LEHIGH PERMANENTE QUARRY RECLAMATION PLAN AMENDMENT

Environmental Impact Report
State Clearinghouse No. 2010042063
Mine ID No. 91-43-0004

Santa Clara County
Department of Planning & Development
Planning Office

May 2012

Figure 3-1
 Regional Surface Geology and
 Locations of Drinking Water Wells

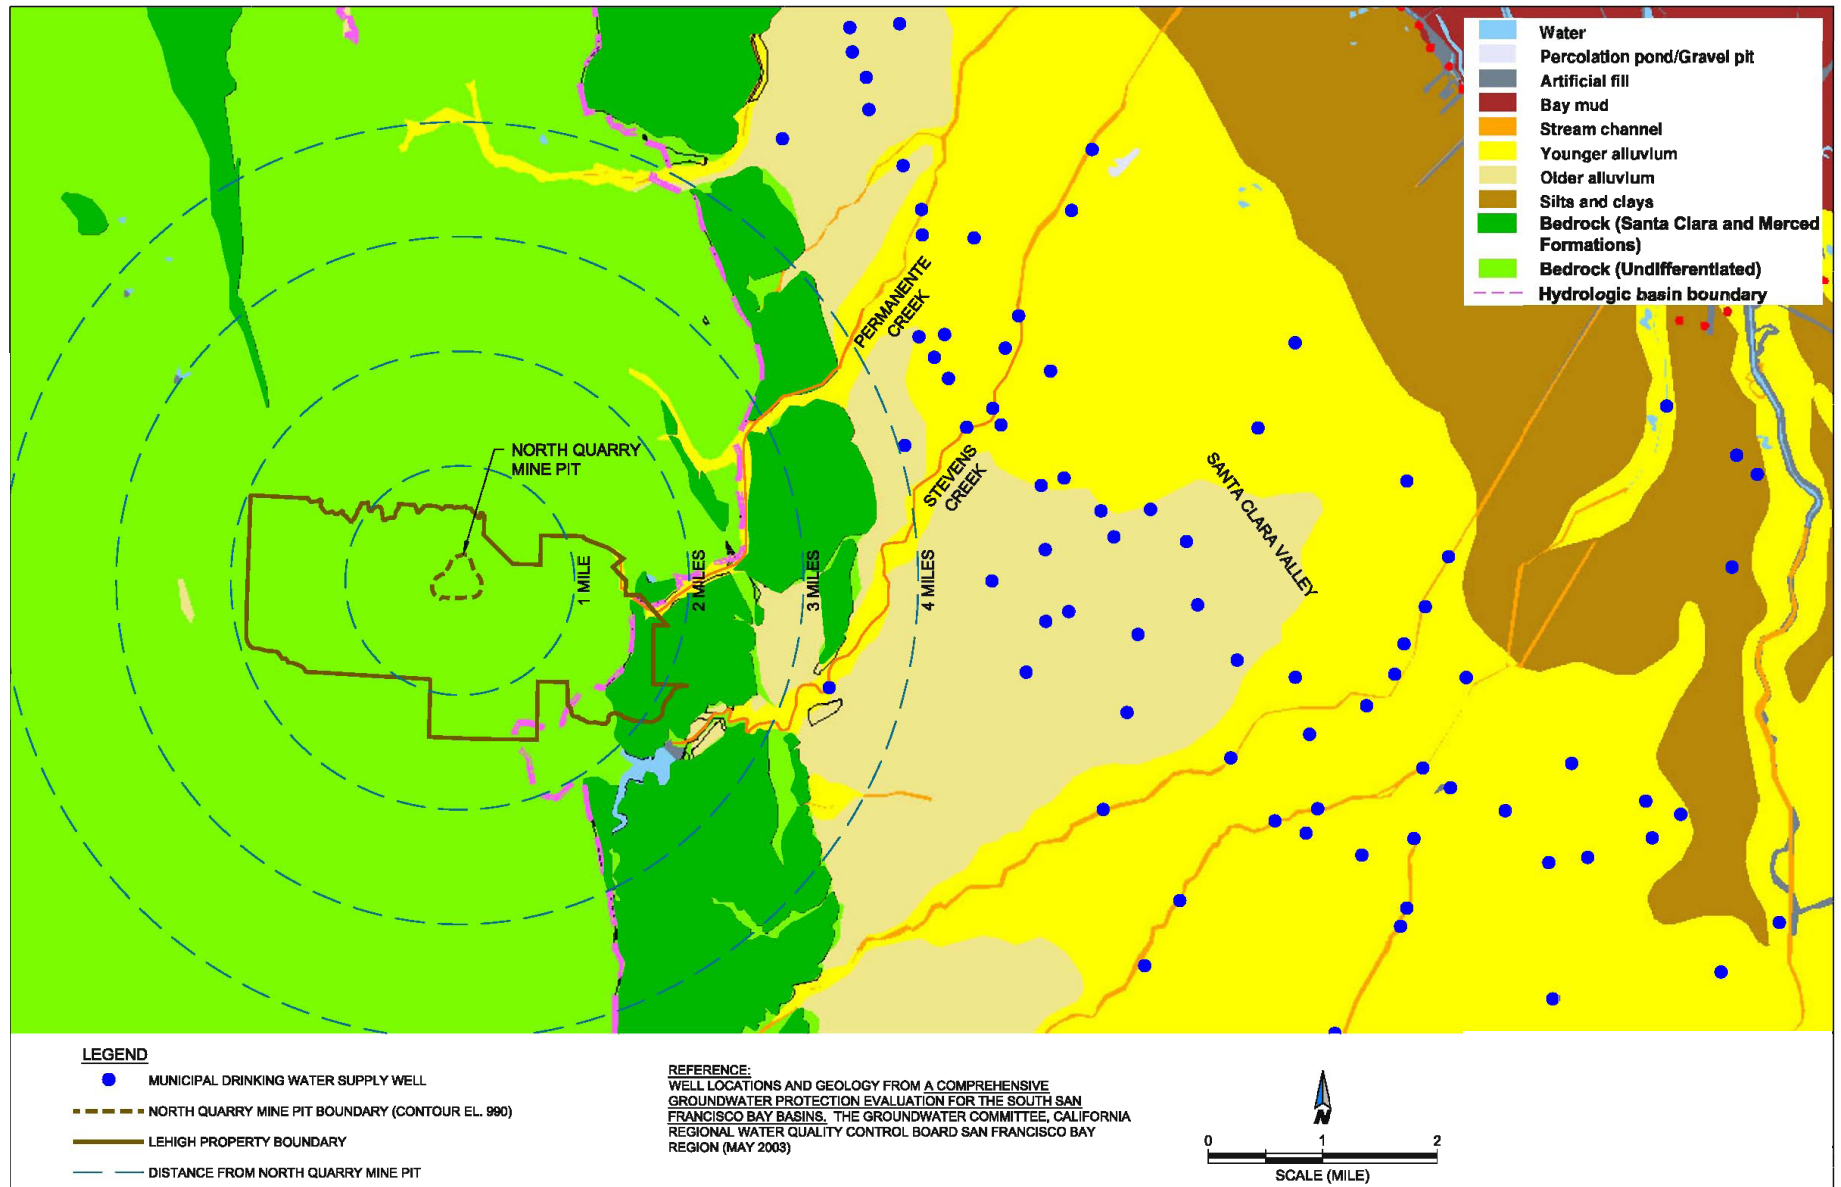
- A. The Project would adversely affect groundwater quality beneath the Project Area and in the water supply aquifers in Santa Clara Valley.

Several comments expressed concern that the Project would result in contamination of the groundwater beneath the Project Area and in the municipal supply wells located to the east in Santa Clara Valley (see, for example, comments A3-2, A3-5, A4-18, P17-1, P17-2, P17-13, P17-14, P17-15, P17-22). Two comments questioned the effects of groundwater flow and quality from backfilling the Quarry pit under the proposed RPA (comments A3-3, O6-6). Given that the discussion of these general issues are similar, they are addressed together in this Master Response. This Master Response provides further clarification of the site-specific and regional groundwater conditions and presents supplemental information regarding the predicted effects that the Project would have on groundwater quality beneath the Project site and whether the proposed changes to the onsite groundwater conditions would have an effect on the municipal groundwater supply wells located in the shallow recharge and deep primary aquifer of the Santa Clara Subbasin. The analysis relies on existing information and data provided by various studies completed by Golder Associates (Golder Associates, 2010; Golder Associates, 2011) and Strategic Engineering Sciences, Incorporated (SES, 2011; SES 2012b). Reports prepared by Golder and SES were considered the primary technical documents for the analysis of the Project impacts under CEQA, and were peer reviewed by the County and the County's consultants, ESA and Balance Hydrologics. The peer review determined that the technical reports were adequate to support the impact analysis in the Draft EIR.

As described in the Draft EIR, the Quarry is located in the southeastern foothills of the Santa Cruz Mountains, which are underlain by a set of volcanic and sedimentary rocks regionally referred to as the "Franciscan Complex" (Draft EIR Section 4.7.1.1, page 4.7-1 and Figure 4.7-1). These rocks have been displaced by hundreds of miles; altered under high heat and pressure (i.e., variably metamorphosed); and faulted, folded, and uplifted by tectonic forces over millions of years. Along the far eastern boundary of the Project Area, the Santa Clara Formation is exposed, which is a more permeable deposit of unconsolidated to slightly consolidated conglomerate, sandstone, siltstone, and claystone. The Santa Clara Formation lies directly upon the eroded surface of the Franciscan Complex bedrock within the central and eastern portions of the EMSA (Draft EIR Section 4.7.1.1, page 4.7-5). The Santa Clara Formation bedrock contacts valley alluvium approximately 1 mile east of the Project Area in a zone of transition from the bedrock of the Santa Cruz Mountains to the alluvial deposits of the Santa Clara Valley (see **Figure 3-1**). The alluvium at the valley margin is referred to by the Santa Clara Valley Water District (SCVWD) as the Santa Clara Subbasin Recharge Area (SCVWD, 2010). Beyond the Subbasin Recharge area is the deeper confined zone of the Santa Clara Subbasin. The majority of municipal groundwater supply wells nearest the site are located over 2 miles to the east in the principal aquifer of the Santa Clara Confined Zone (Figure 3-1).

A. Description of Onsite Detention Facility

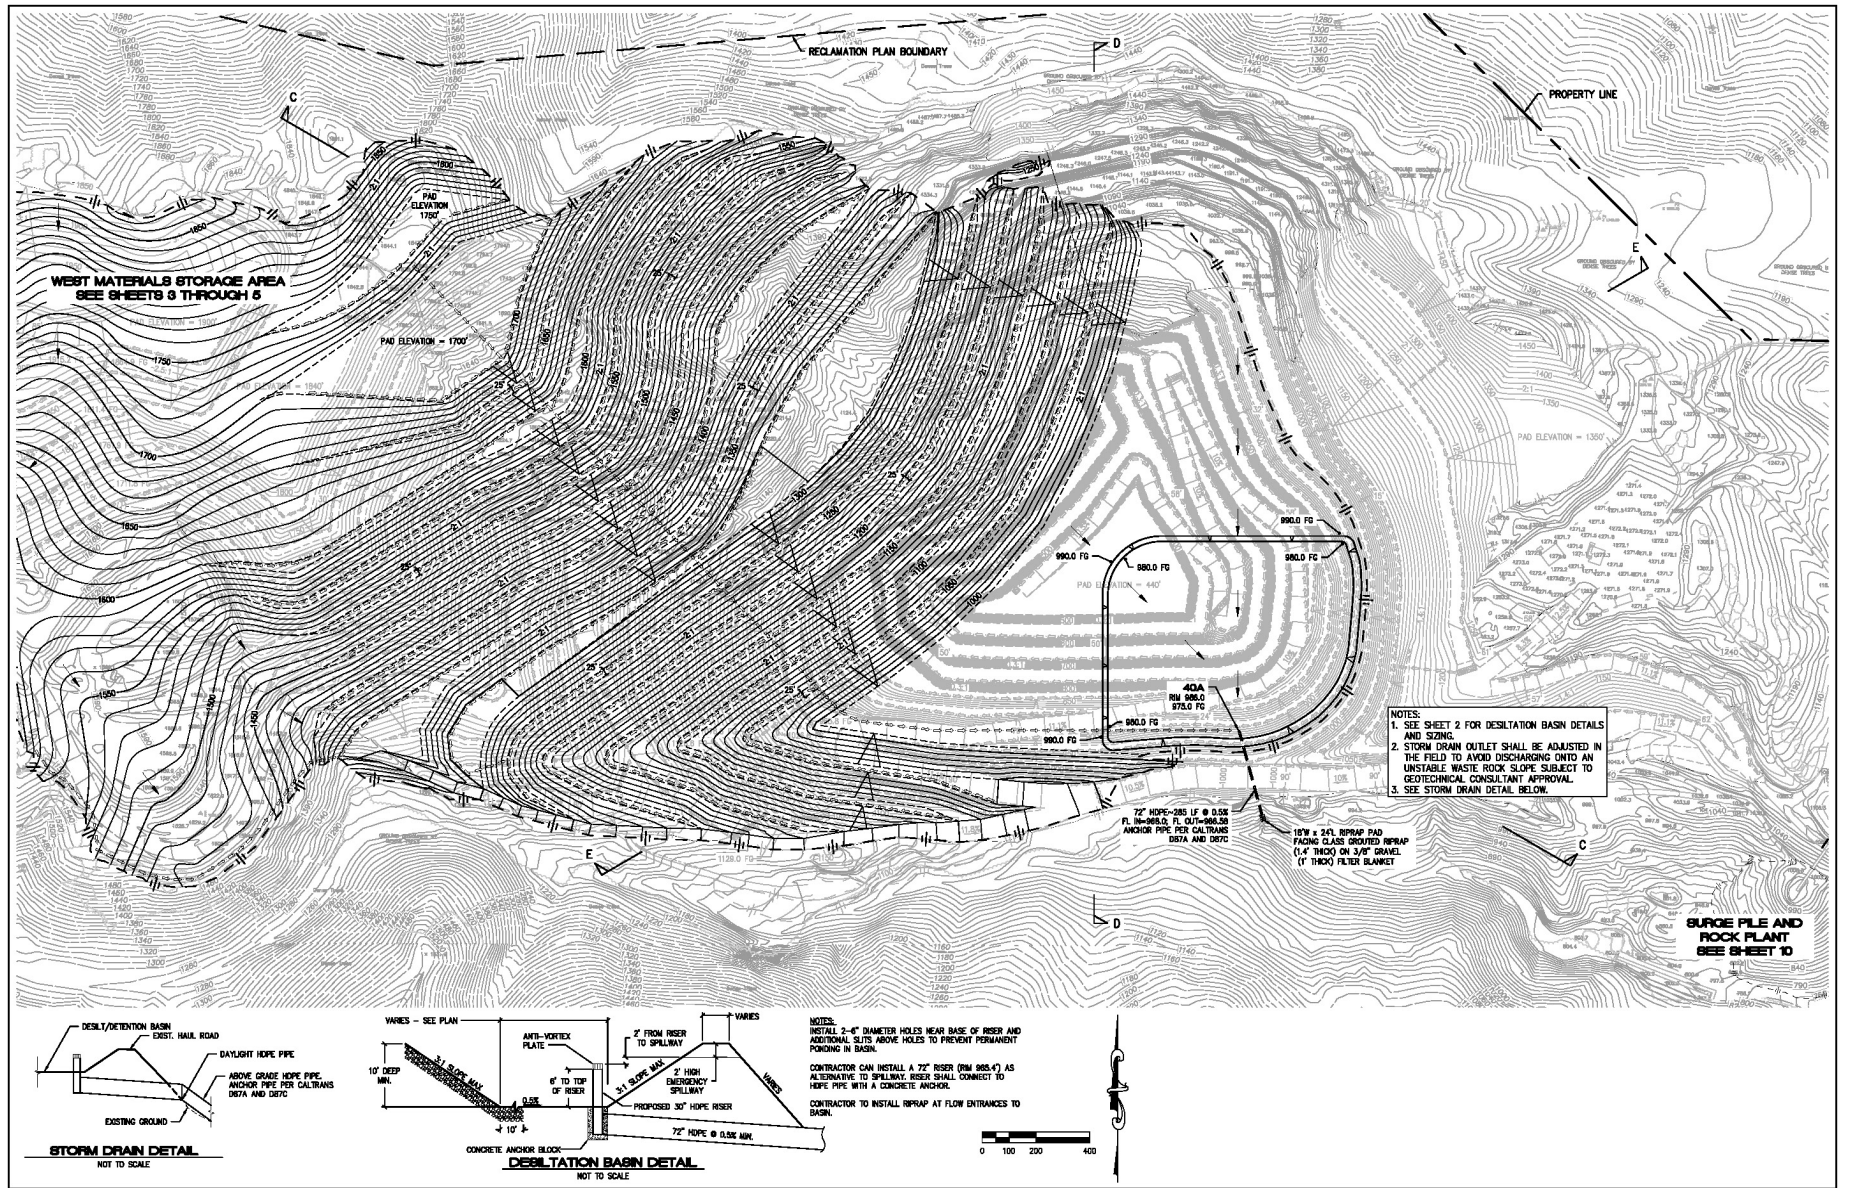
Subsequent to publication of the Draft EIR, the Applicant coordinated with the Santa Clara Valley Water District (SCVWD) to address the potential increased risk of offsite flooding, and designed a detention basin located on the reclaimed Quarry pit floor. The proposed detention basin, referred to as new Basin 40A, is described (and shown in Figure 3-1). Analysis by hydrologists and engineers has shown the proposed detention basin to be feasible, and sufficient to satisfy the criteria outlined in Draft EIR Mitigation Measure 4.10-4 to mitigate impacts pertaining to flooding to a less than significant level. Accordingly, the following language from the Draft EIR has been revised to clarify Mitigation Measure 4.10-4 based on the details of Basin 40A:

The new onsite detention facility, referred to as Basin 40A, has been designed to function as a desiltation and detention basin and therefore, the proposed volume is much greater than the previous desiltation basin described by Chang (2011). Basin 40A would be approximately 700 feet by 1000 feet in plan dimension and approximately 10 feet deep. As shown in **Figure 3-2**, the basin would occupy about half of the proposed reclaimed Quarry pit surface and the outside extent would follow the curvature of the proposed reclaimed slopes. The berm of the basin would be trapezoidal with the interior slopes set at a maximum 3:1 horizontal to vertical (H:V) and the

exterior slopes would vary depending on location. The top of the berm also would vary in width depending on location. The bottom of the basin would be composed of compacted backfill material but would not be lined with an impervious membrane.

Figure 3-3
Comparison of Proposed Reclamation Amendment
Boundary with the Approved 1985 Reclamation Plan Boundary

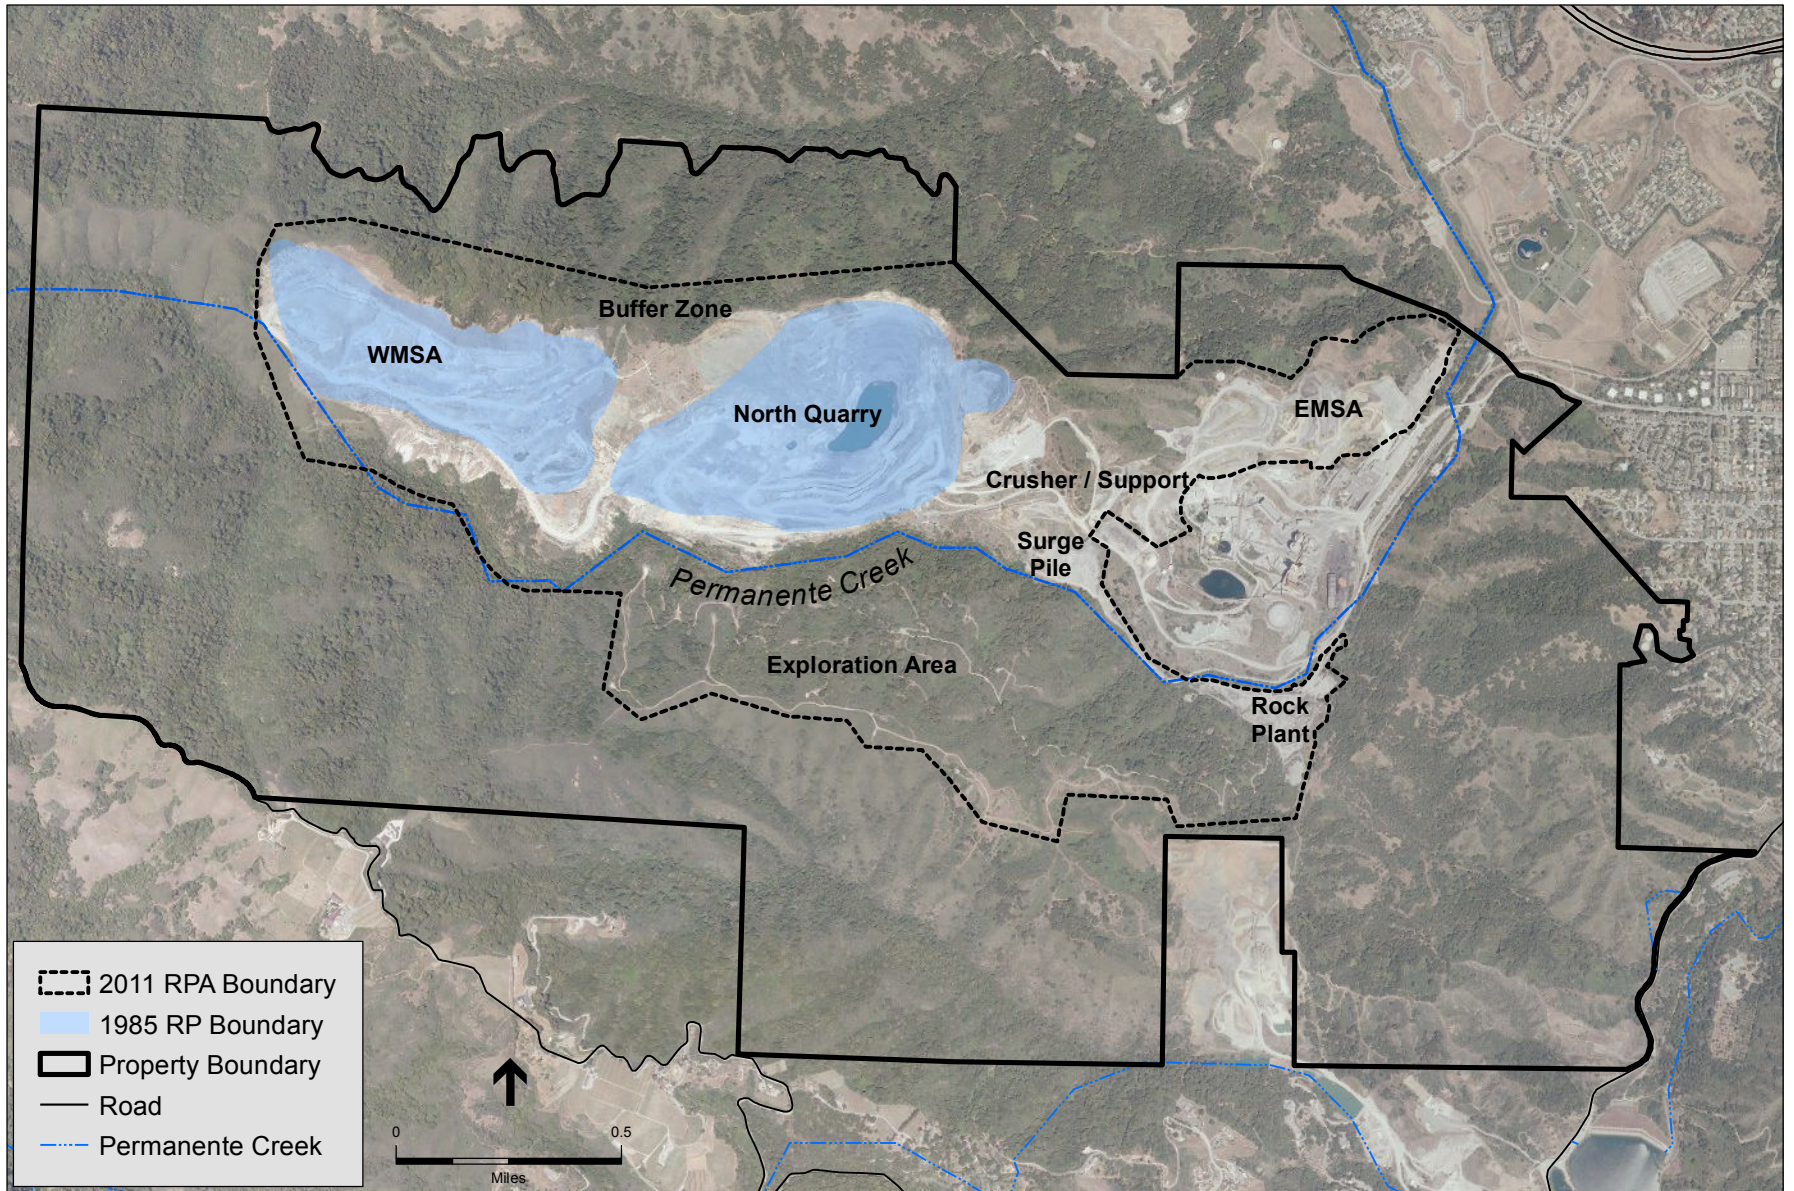
- A6-13 This comment makes the assertion that reclamation activities associated with the EMSA would be constructed in soils that may have been contaminated from past activities related to the manufacturing of magnesium and aluminum at the site. As noted in Response A6-1 and stated in Draft EIR Section 4.4.1.2 on page 4.4-17, the former manufacturing plant building is outside the Project Area, including the EMSA footprint. The County has reviewed the Applicant's reclamation plan application materials and can find no reference or figures showing any EMSA construction proposed for the former metals manufacturing area. As this comment provides no substantiating evidence to the contrary, the County maintains that the Draft EIR adequately assesses the potential impacts related to hazards and hazardous materials (Draft EIR Section 4.9, page 4.9-1 et seq.), as it relies on regulatory agencies' records, existing hazardous materials use in the Project Area, and site-specific historical conditions.

A comparison of the proposed Reclamation Plan Amendment boundary with the approved 1985 Reclamation Plan boundary was provided as Figure 1.0-5 in the Reclamation Plan Amendment. A similar figure was not provided in the Draft EIR because the Draft EIR evaluates the significance of Project-related changes relative to actual physical conditions in the environment, not to physical limits established by prior approvals. However, a figure comparing approved and proposed reclamation boundaries for the Permanente Quarry is provided as **Figure 3-3** in this Final EIR for informational purposes and in response to this comment. In it the actual extent of operations current as of the mapping capability can be seen in relation to the reclamation plan boundaries.
